AIRPORT BOARD OPERATIONS COMMITTEE AGENDA

August 16, 2022 at 2:00 PM

JNU BLOCK M HANGARS
DRAINAGE ANALYSIS

Subject: Fw: Block M flooding

FIGURE 1

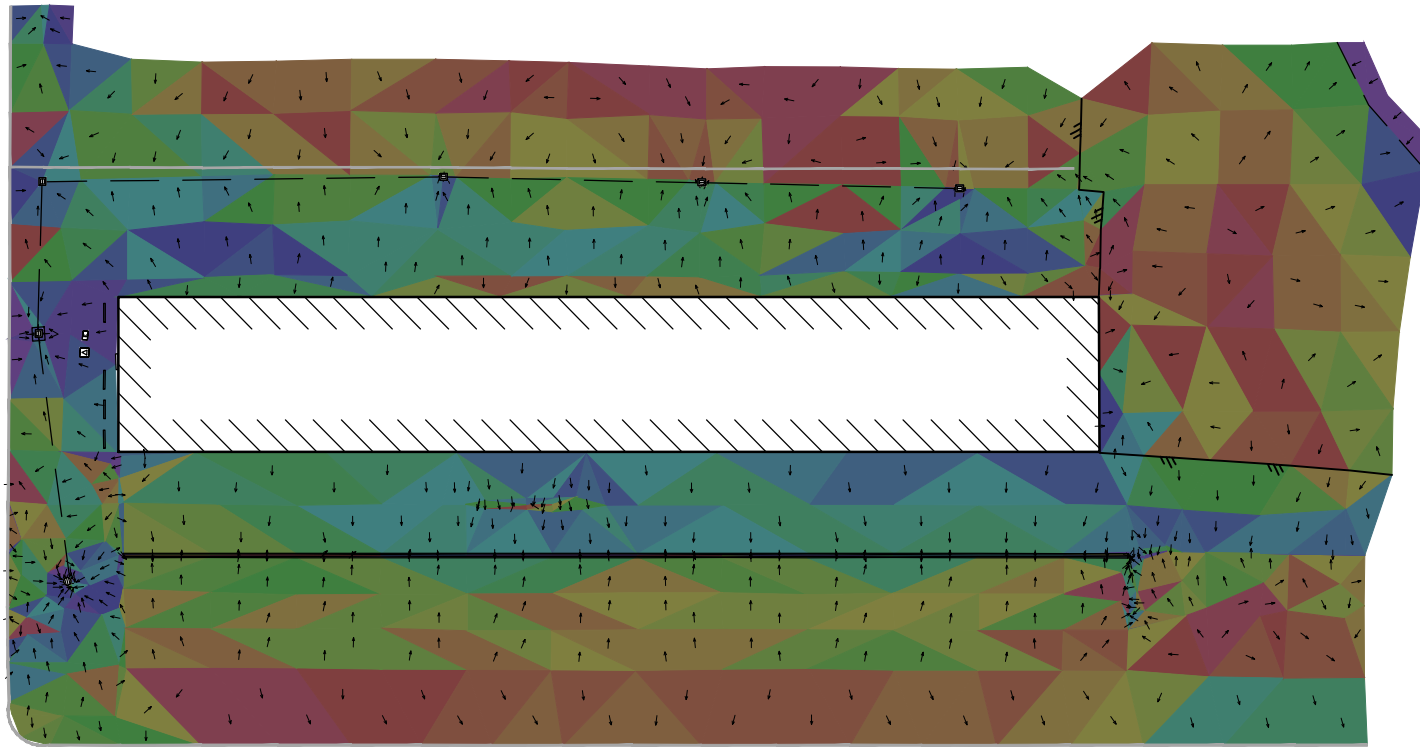
The attached survey heat map (Attachment #1) was created by DOWL from survey data collected around the Block M hangars. This map confirms what we already knew – that the site is extremely flat and that it drains poorly.

The map shows that most of the surface slopes within the five-foot lease line strip on the north side of the hangar actually slope towards the hangar. The slopes outside (north of) the lease line slope to the north towards the existing area drains. Having never worked on this side of the hangar and only recently receiving complaints of water infiltration, this reverse slope comes as a bit of a surprise.

the map shows that the surface generally slopes away from the hangar and towards the existing area drain.

The map shows that all of the surface slopes within the five-foot lease line strip on the south side of the hangar slope away from the hangar. All of the slopes outside (south of) the lease line slope away from the hangar to the existing strip drain. This confirms what we already knew and confirms that the efforts put into the recent tarmac and strip drain revisions have resulted in surface slopes that drain water away from the hangar.

The map shows that the surface is generally flat, with areas that slope towards the hangar and areas that slope away from the hangar. There are no existing catchment drains of any kind on the east side of this hangar.

- 8) To my untrained eye viewing the drainage analysis plot provided by DOWL, it appears that the slope(s) of the area immediately north of the Block M hangars (the taxilane between Block M and Block L), is/are comparable to or less than those on the south side of Block M. Yet we have received fewer complaints from the north side of Block M and none that I am aware of from Block L. The area north of Block M is drained by multiple large grate type drains while the area to the south has only one long trench type drain. The area south of Block J (west side, between Aero Services and the CAP) is drained by a similar trench drain. Last winter during a period of heavy rain and snow melt-off, I observed this drain to be completely overwhelmed. Could it be that trench drains aren't up to the demands of Juneau weather conditions?
